We are seeking your permission and advice on behalf of our client for the relocation of the bus stop in the boundary of the property at 1110 Victoria Rd, West ryde to have the proposed driveway for a duplex development.

1110 victoria rd,west ryde sur...

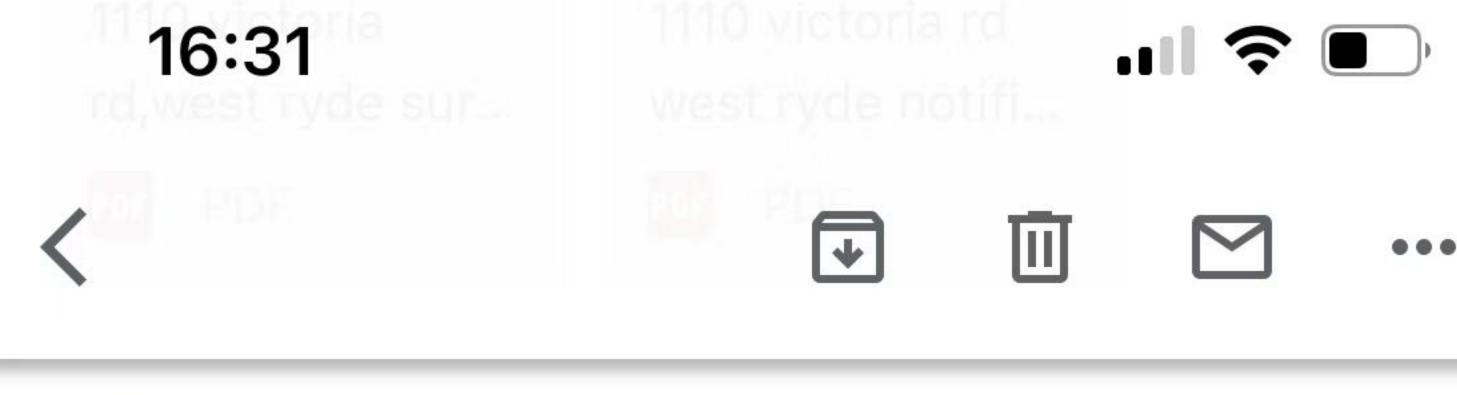
The location for the proposed driveway is the only location we can choose since council requires us to have a turning bay to head out the vehicle on the main road. Please see survey plan and architectural plans attached for your information.

Please advise if we are able to relocate the bus stop within our front boundary.

I see no issues with the relocation of the bus stop and associated infrastructure at No 1110 Victoria Road, West Ryde.

I would suggest that the signage be installed west of the new driveway so as when a bus does stop at the location, it will be across the driveway for a very short time, thus reducing any impact to the neighbouring properties.
